ATTACHMENT 4

UNIT 2 – AREA WALK-BY CHECKLISTS

NO. SNCV061-RPT-02

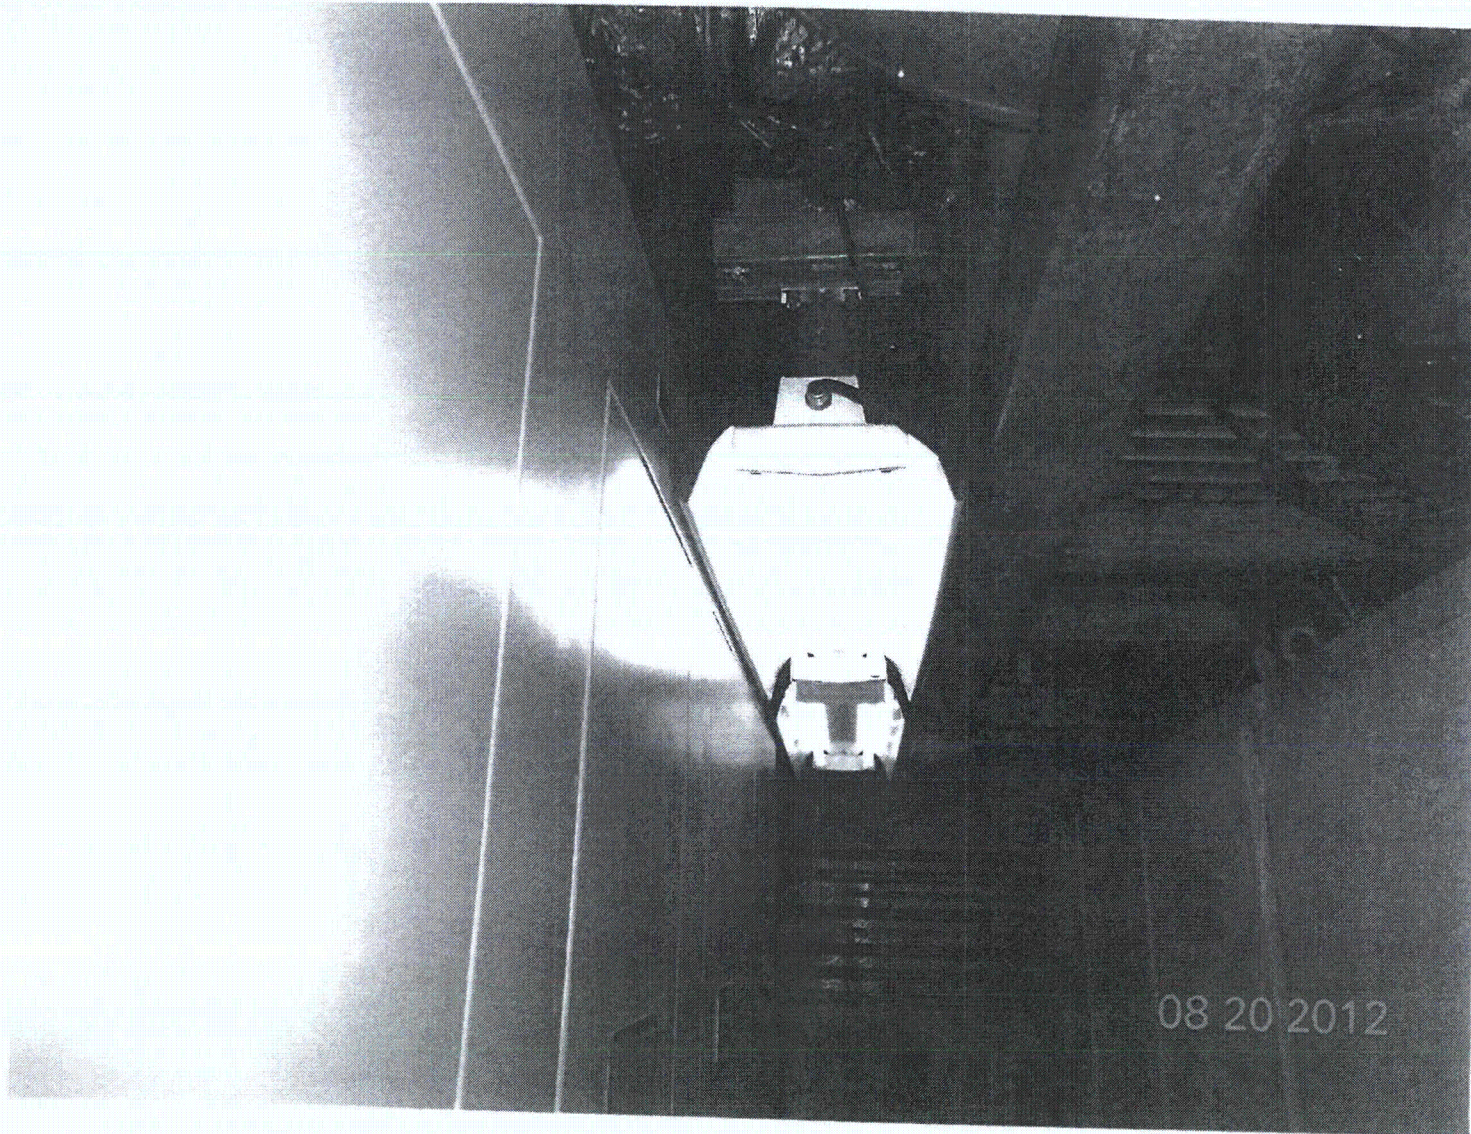
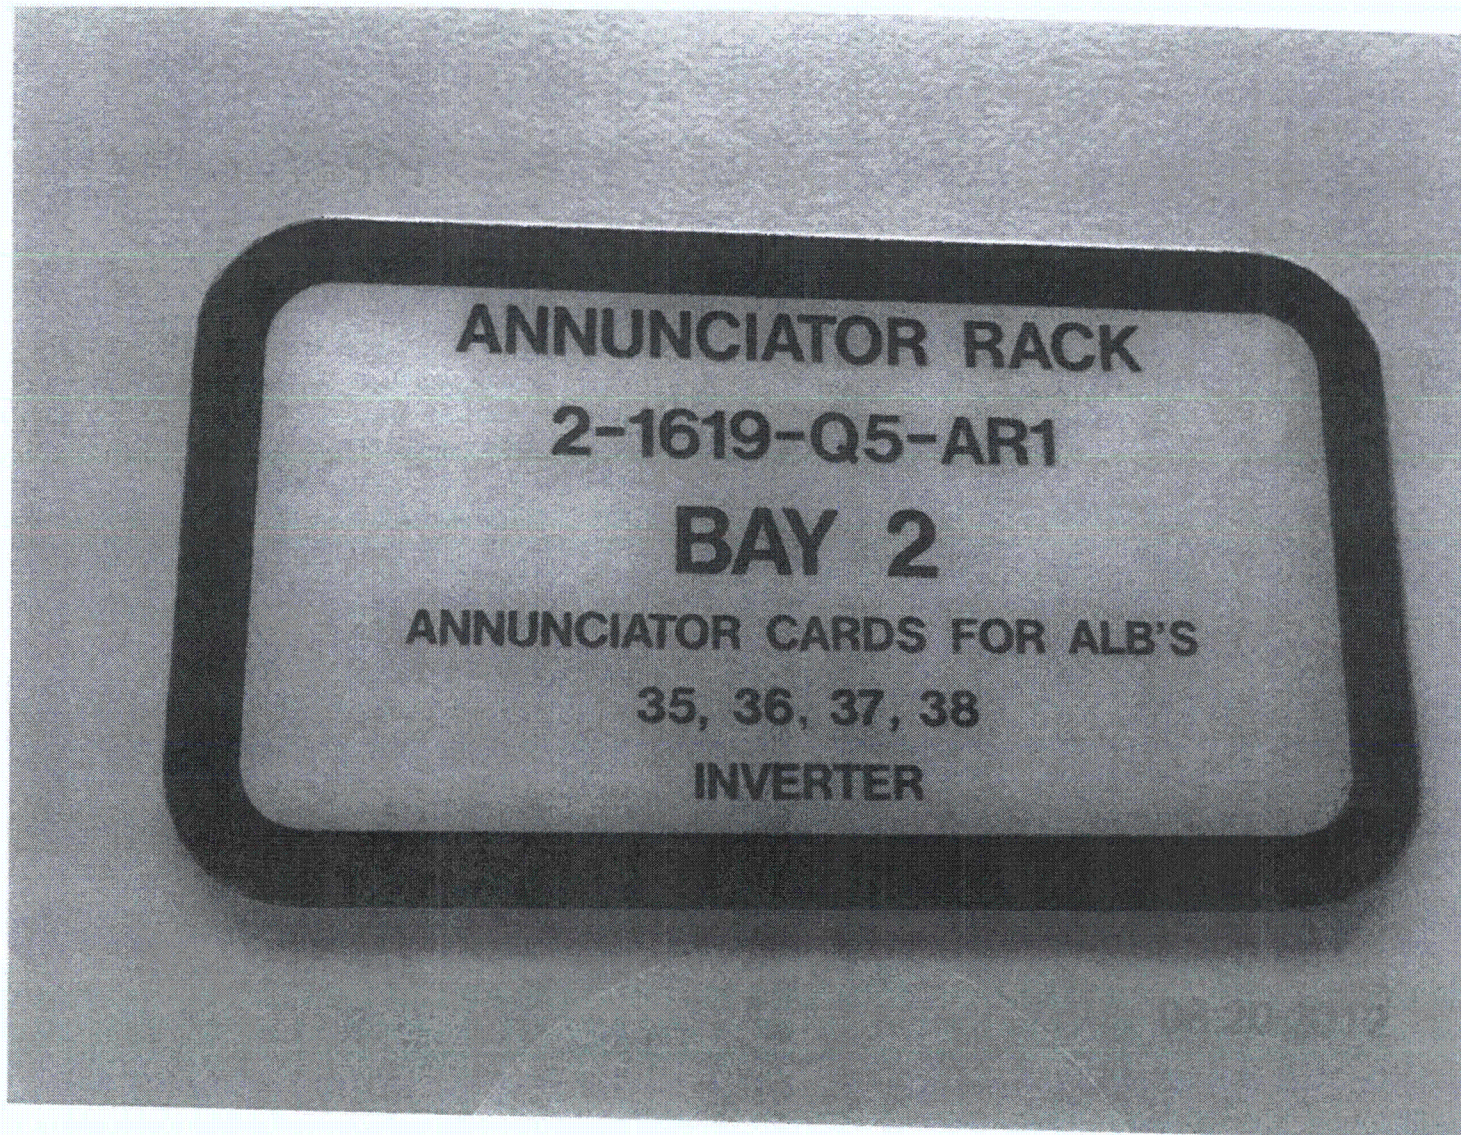
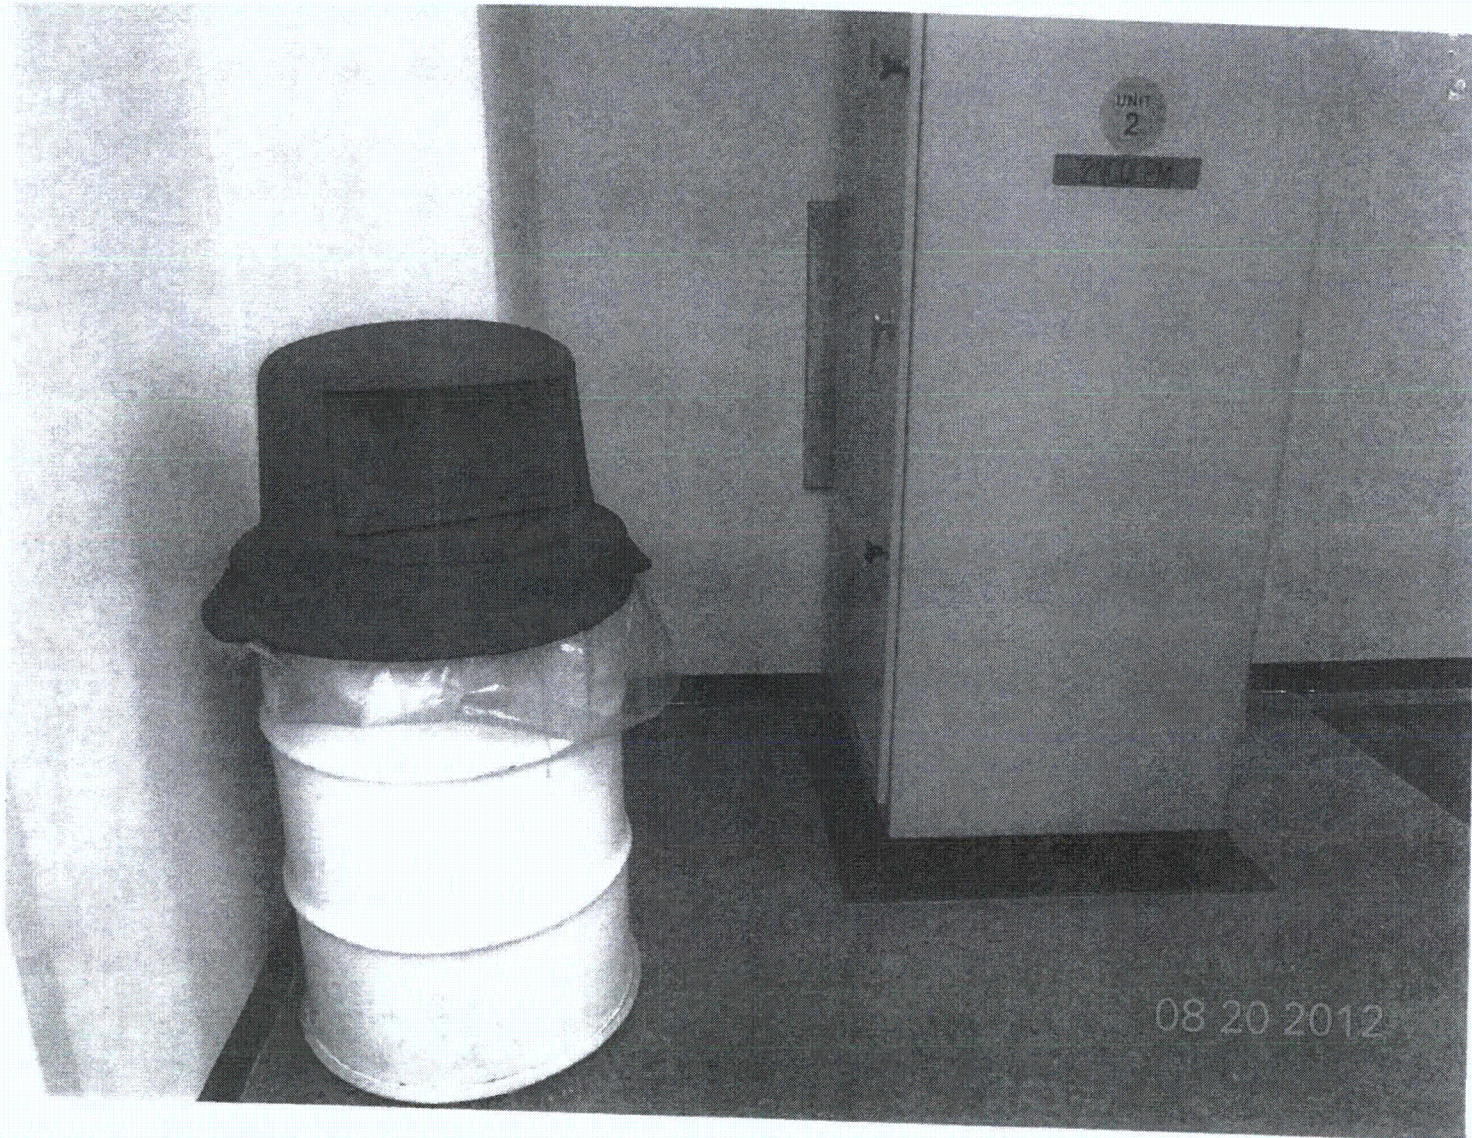
TRASH BARREL ADJACENT TO CABINET 2NCQLPM IS NOT RESTRAINED (SEE SHEET FOR PICTURE) REFER TO CR 517075. BV 8/20/12

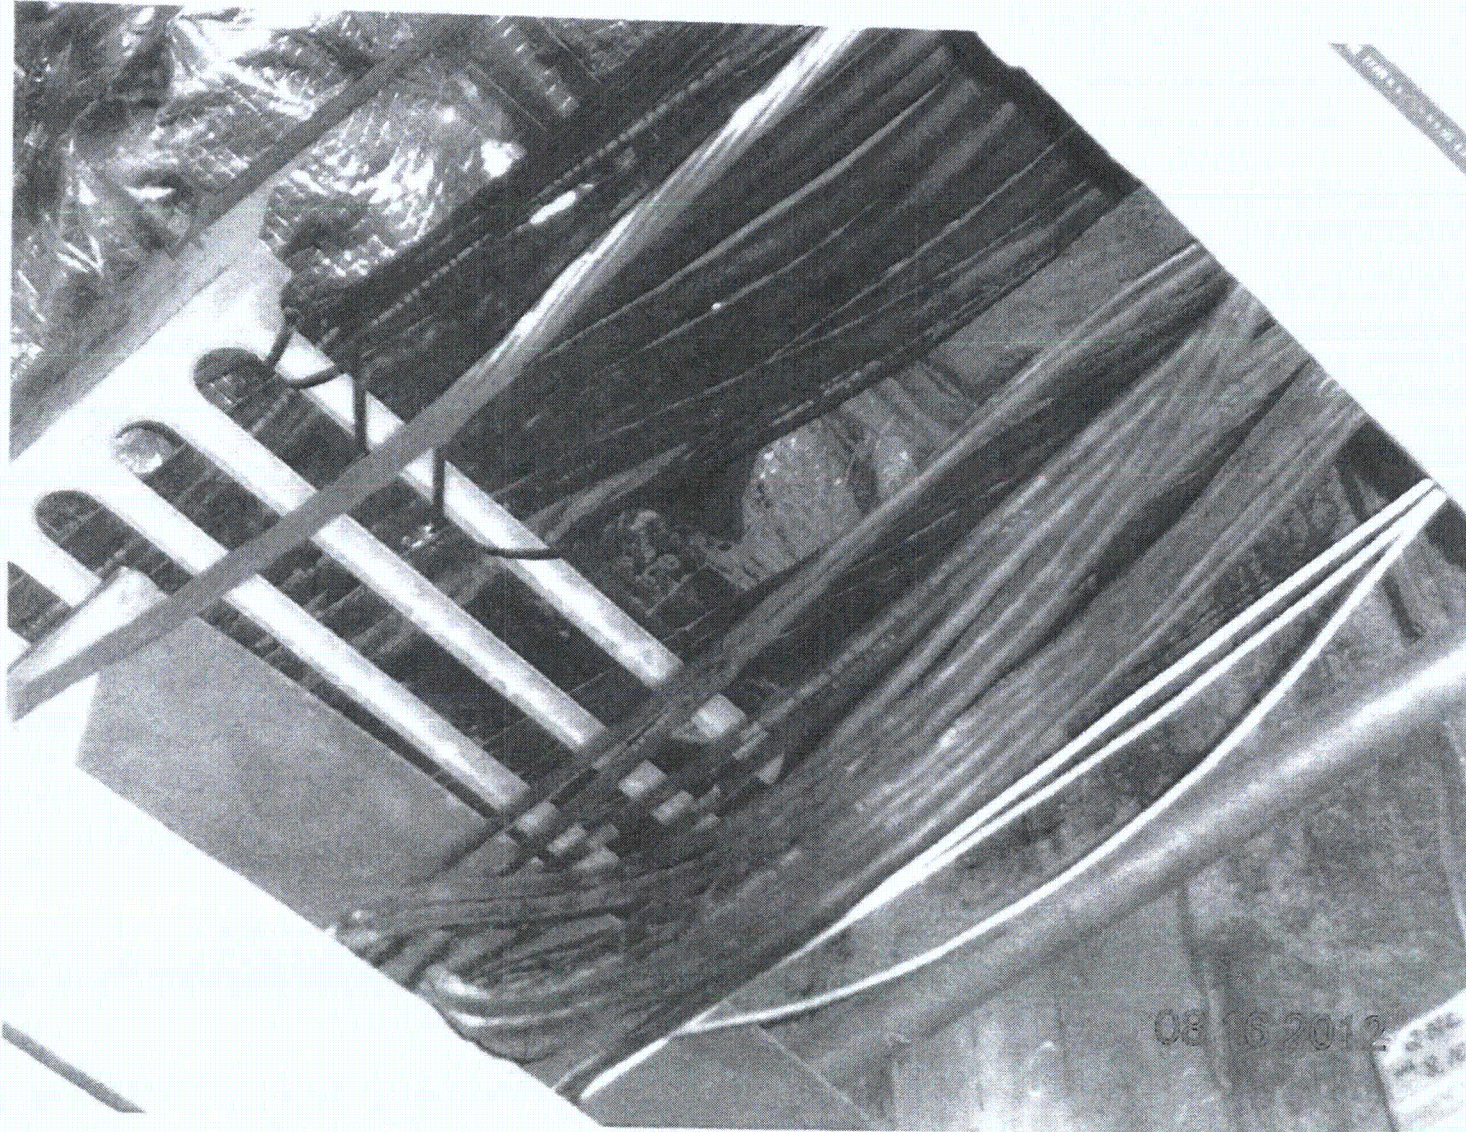
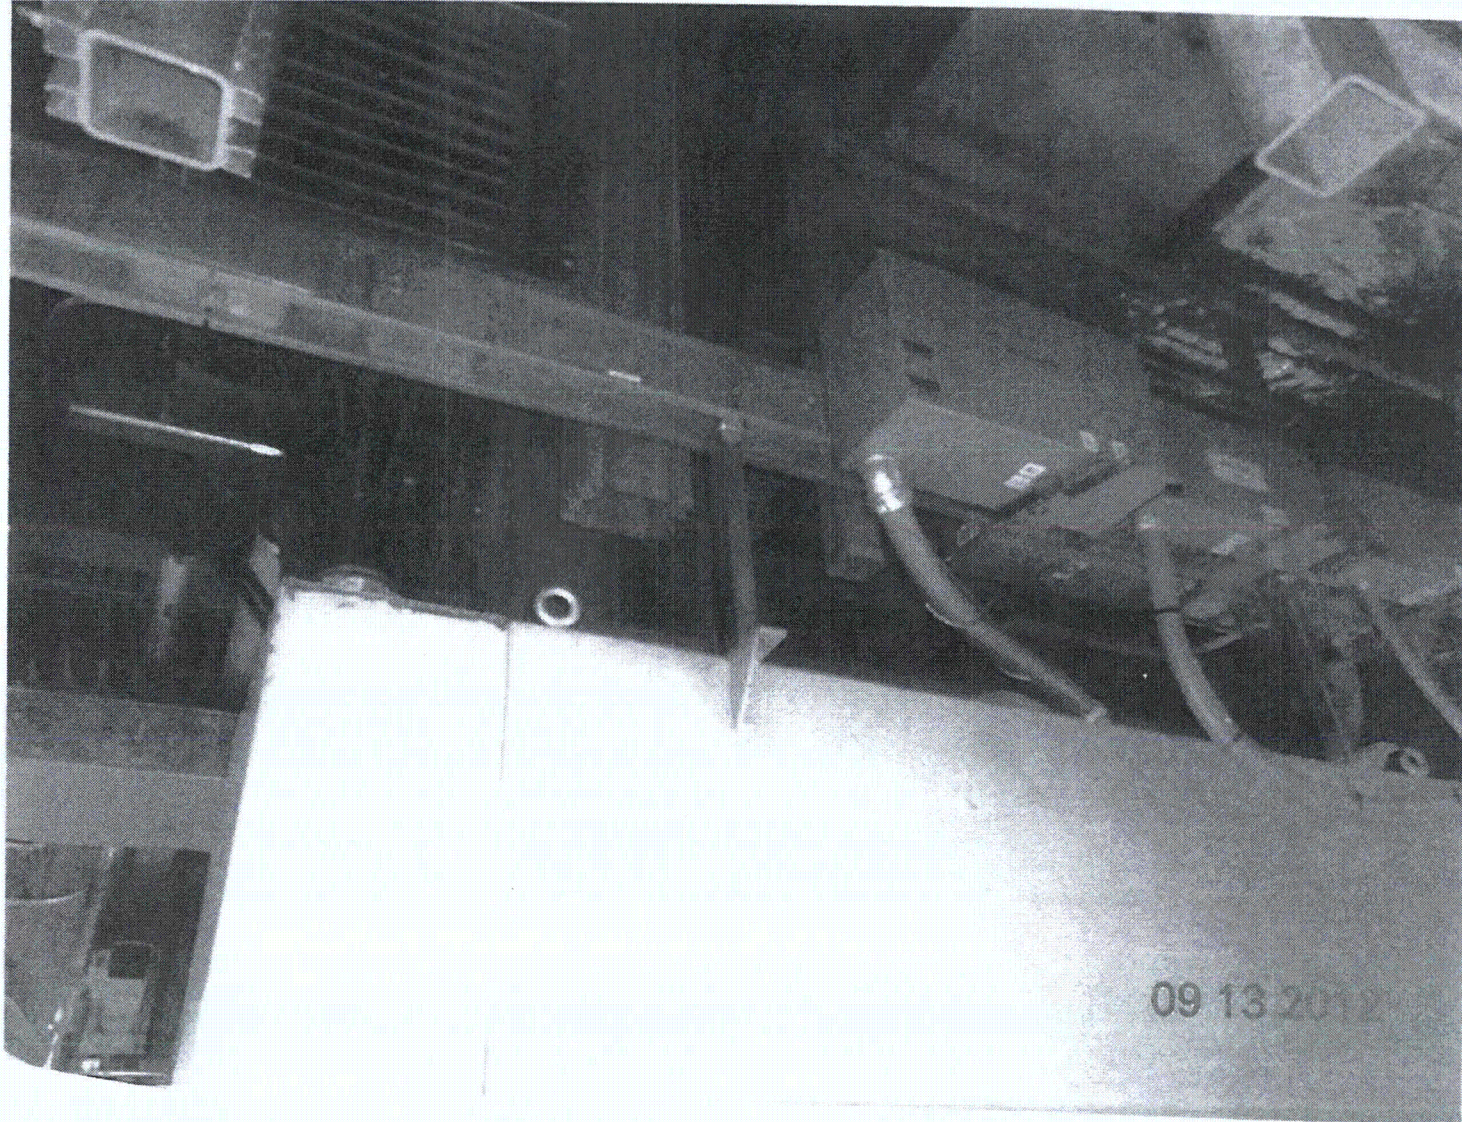
DV 8/16/12
BUS DUCT COMING FROM SWITCHGEAR 2-1606-56-002 RUNS ACCROSS THE ROOM, AND ALSO SUPPORTED BY CABINET 2-1606-43-FLR-005 (RIGIDLY ATTACHED). REFER TO CR 517082.
